A. DESCRIPTION OF THE PROPOSED CHANGE

This proposed amendment will revise Technical Specification Figures 3.1-3 and 3.1-4. These figures provide regulating group Control Element Assembly (CEA) insertion limits. Figure 3.1-3 provides CEA insertion limits when the Core Operating Limit Supervisory System (COLSS) is in service and Figure 3.1-4 provides the insertion limits when COLSS is out of service. The following two changes are proposed:

This proposed amendment will revise Technical Specification Figure 3.2-1A. This figure provides azimuthal power tilt limits versus core power for COLSS in service. The azimuthal power tilt limit will be increased for operation below 40% of rated thermal power.

This proposed amendment will revise Technical Specification Figures 3.2-2 and 3.2-2A. These figures provide DNBR margin limits for various configurations of COLSS and CEACs inoperable. The changes are necessary to ensure that the Technical Specifications are consistent with the safety analyses performed for the Cycle 3 core design.

FIGURE 3.2-2

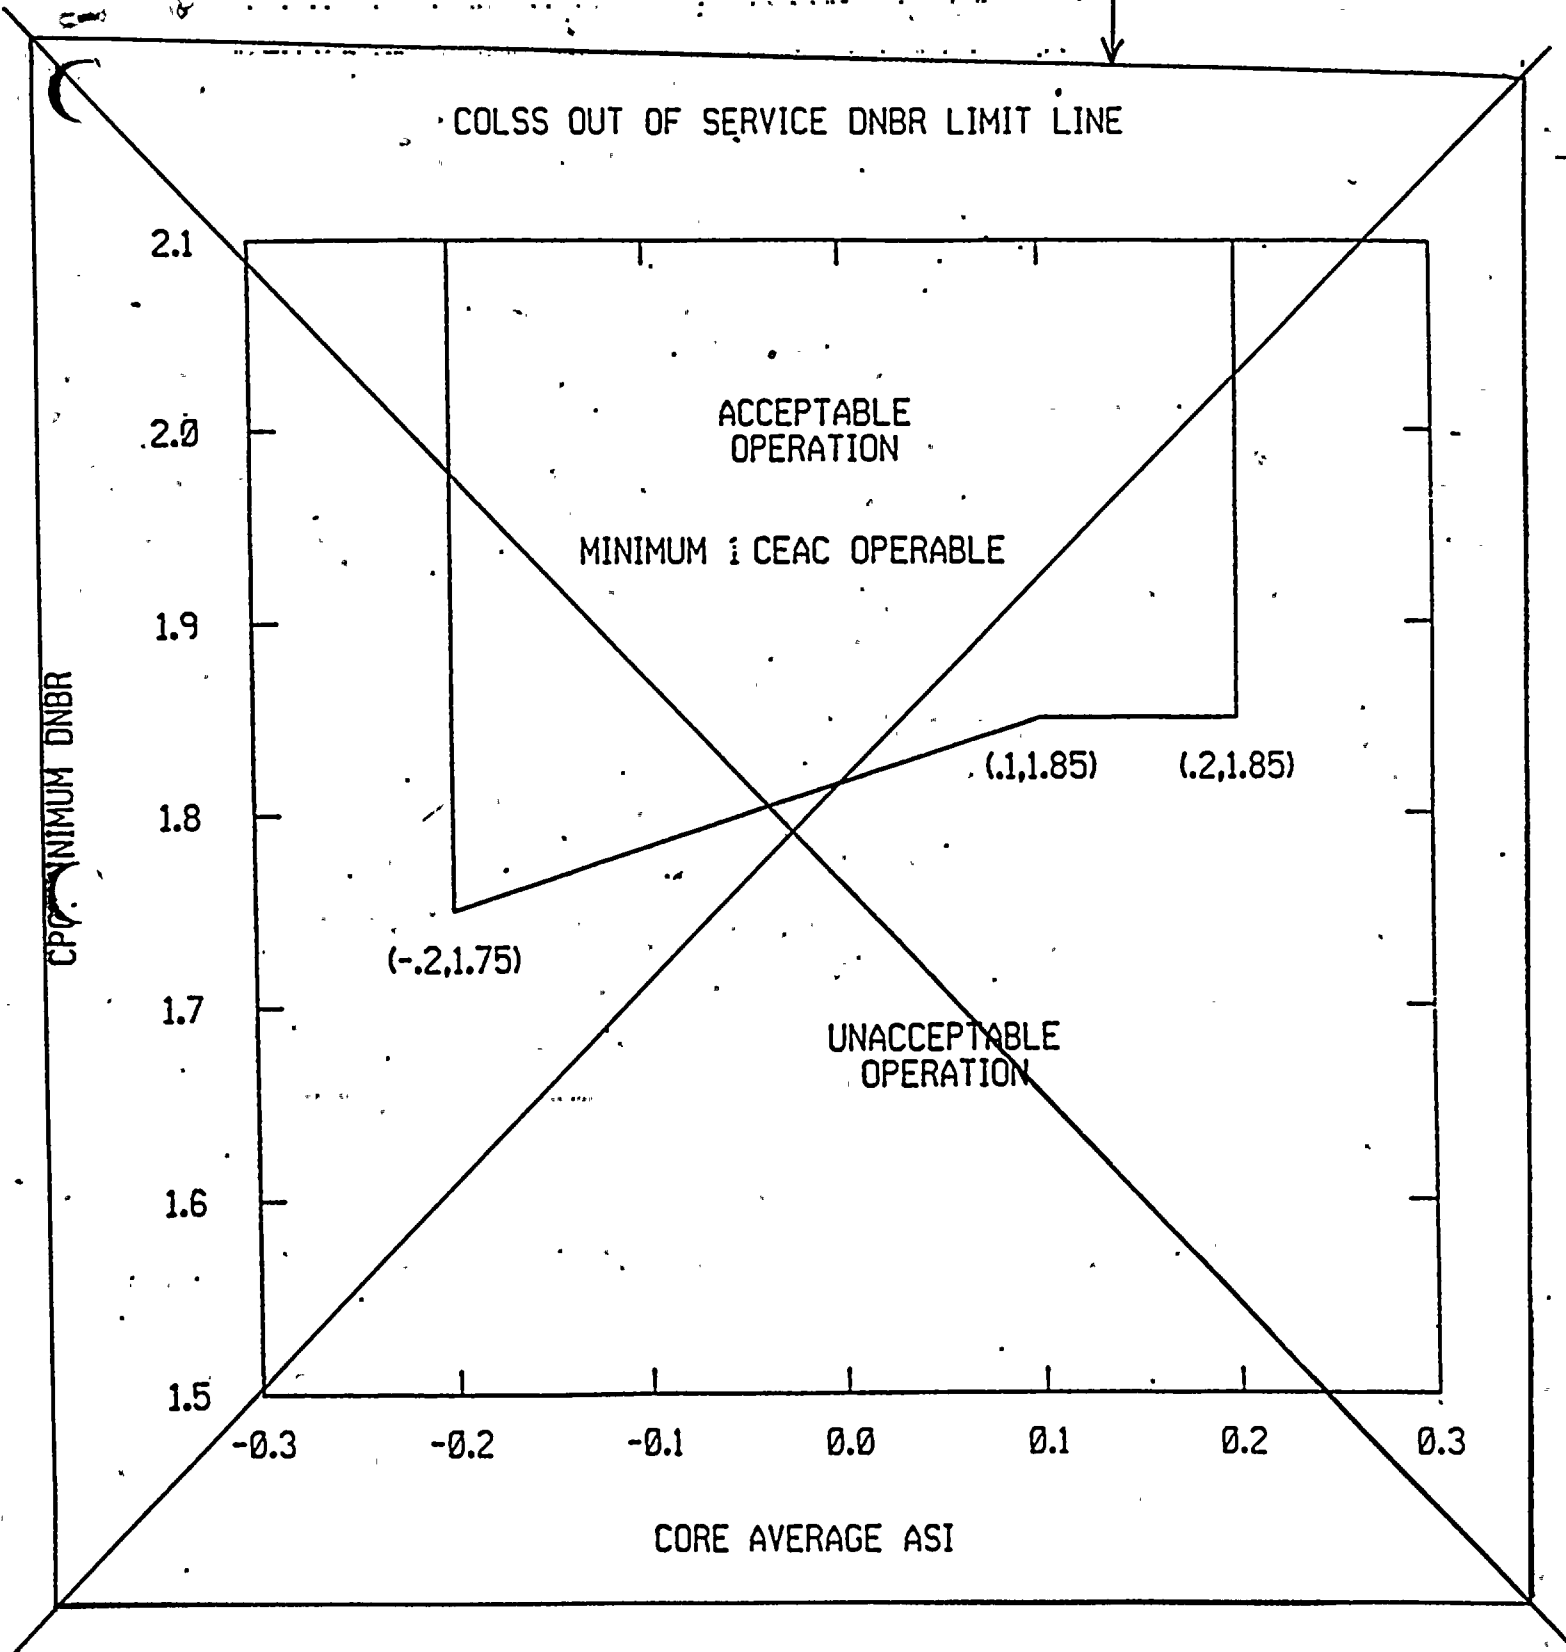
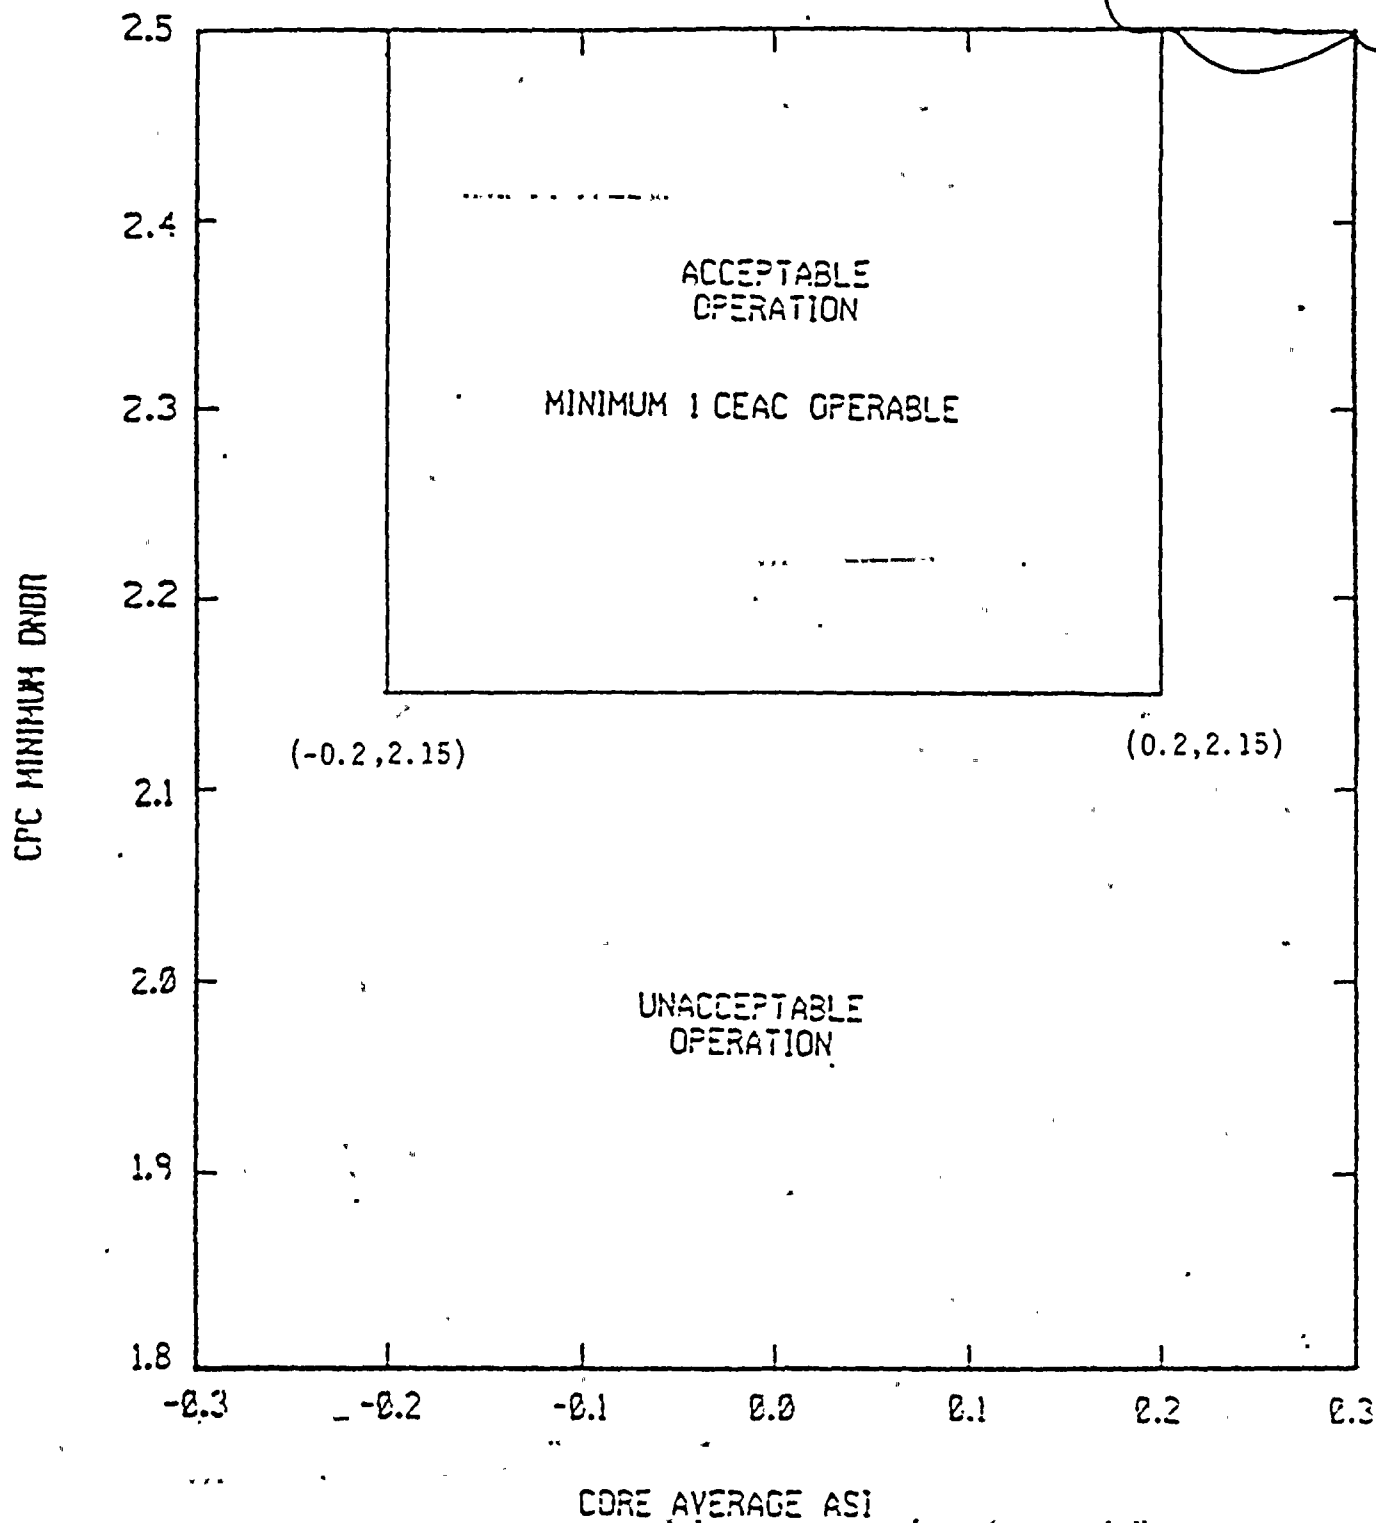
- b. The proposed revision to Figure 3.2-2 accounts for the situation where COLSS is out of service and at least one CEAC is operable. In this case the Cycle 3 safety analyses have shown that by maintaining the CPC calculated DNBR above the value shown in the revised figure, the limiting AOO will not result in a violation of the SAFDLs.
- c. When COLSS and both CEACs are out of service, there must be additional margin in the initial CPC DNBR value to ensure that the limiting AOO will not result in exceeding a SAFDL. The evaluation of the Cycle 3 core design has shown that by maintaining the CPC calculated DNBR above the limits shown in Figure 3.2-2A, the SAFDLs will not be exceeded during the most limiting AOO.

- b. The proposed revision to Figure 3.2-2 accounts for the situation where COLSS is out of service and at least one CEAC is operable. In this case the Cycle 3 safety analyses have shown that by maintaining the CPC calculated DNBR above the value shown in the revised figure, the limiting AOO will not result in a violation of the SAFDLs.
